Mobile Video Recorder

Version: V5.9.2 Release Note

3. Support BSD function linkage acousto-optic alarm

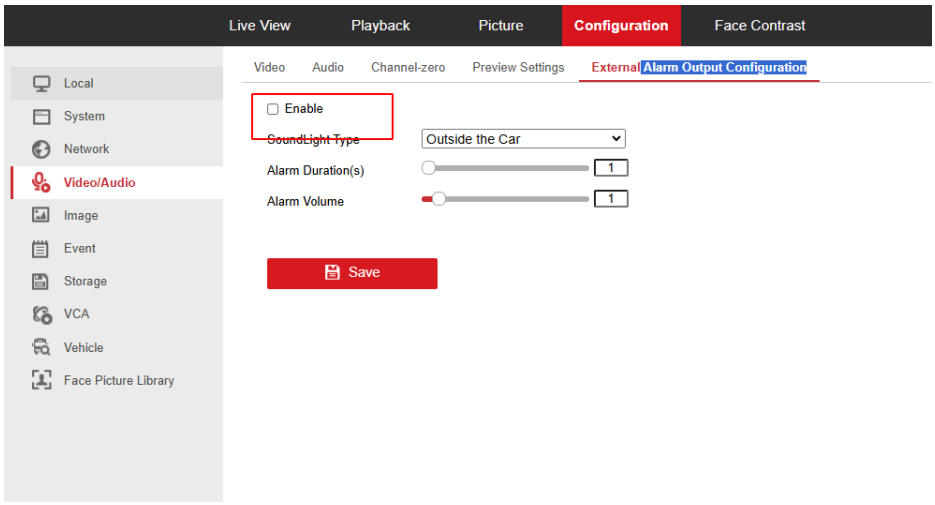
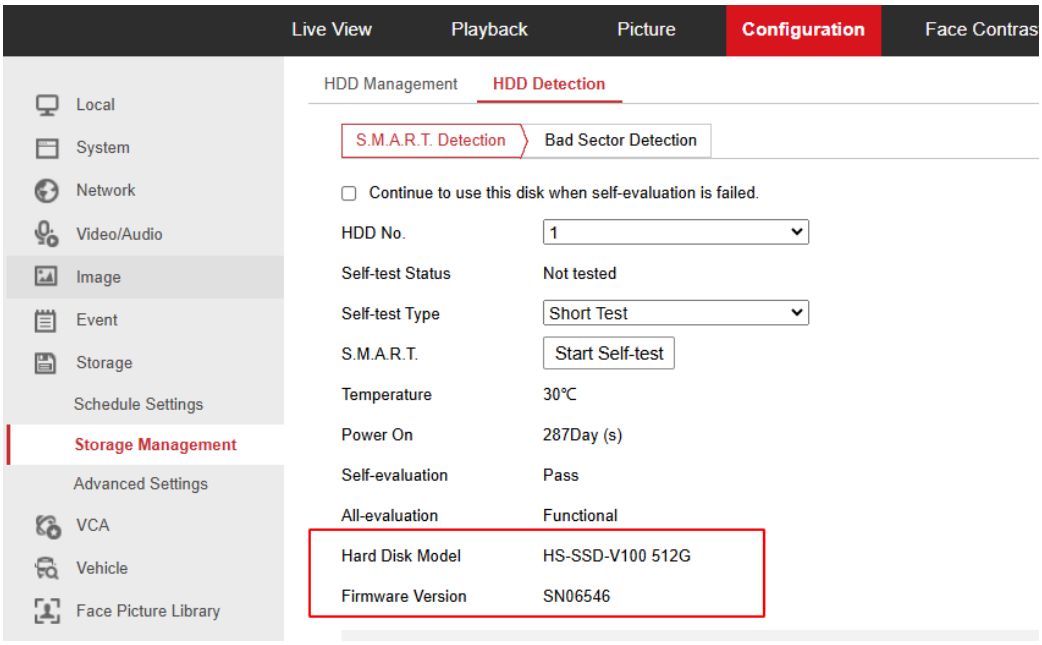
Note: Need connect to 485-2

11. Support exporting IPC related parameters to facilitate project implementation

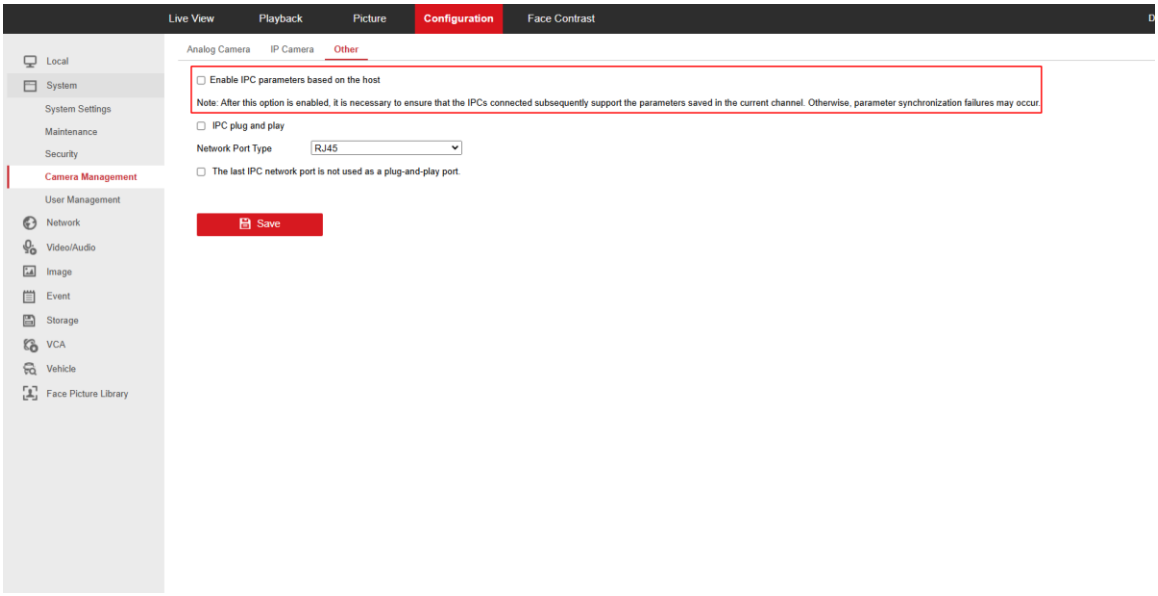
Note：When delivering IP camera projects in batches, keep the order of all MVR channels consistent. After configuring the first MVR, enable the following function and export the MVR parameters. Then, you can import other MVRs to copy the IP camera's stream parameters.

12. Support HCP platform to import and export MVR parameters

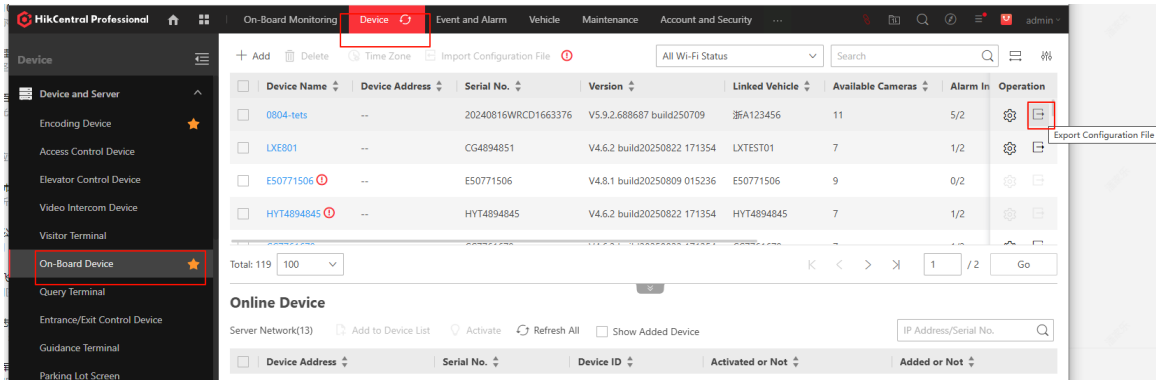
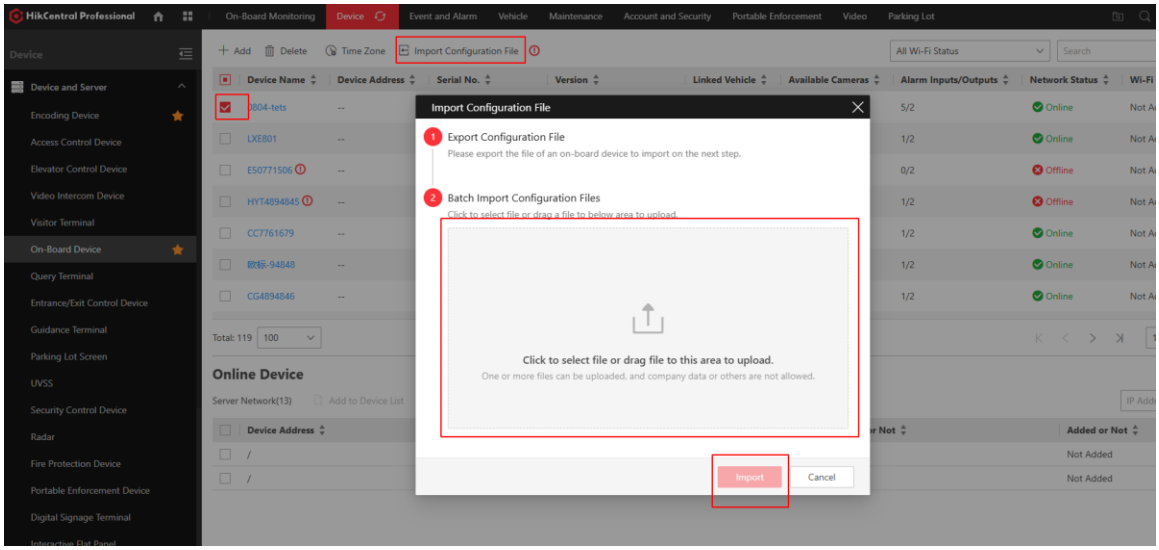
Note: HCP require V3.0.0 and above

13. Support HCP jump to the IPC web page of the MVR

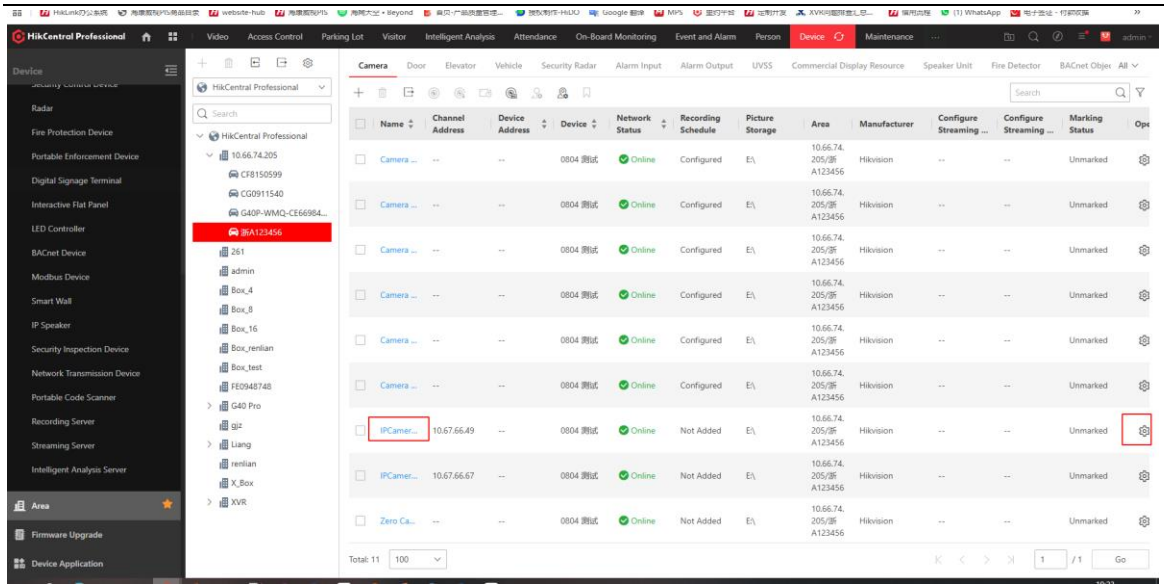
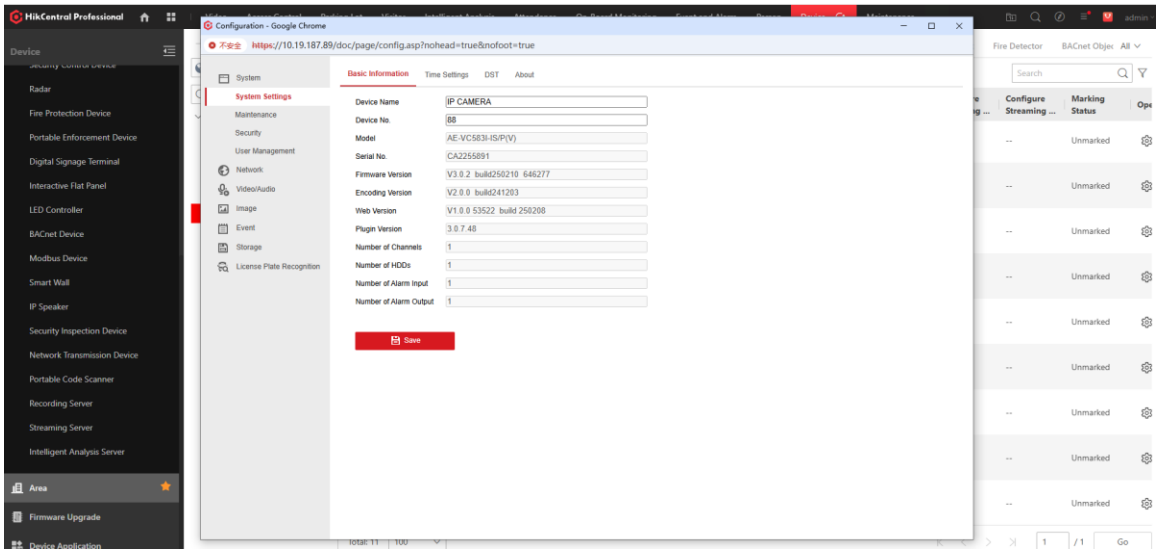
Note: HCP require V3.0.1 and above
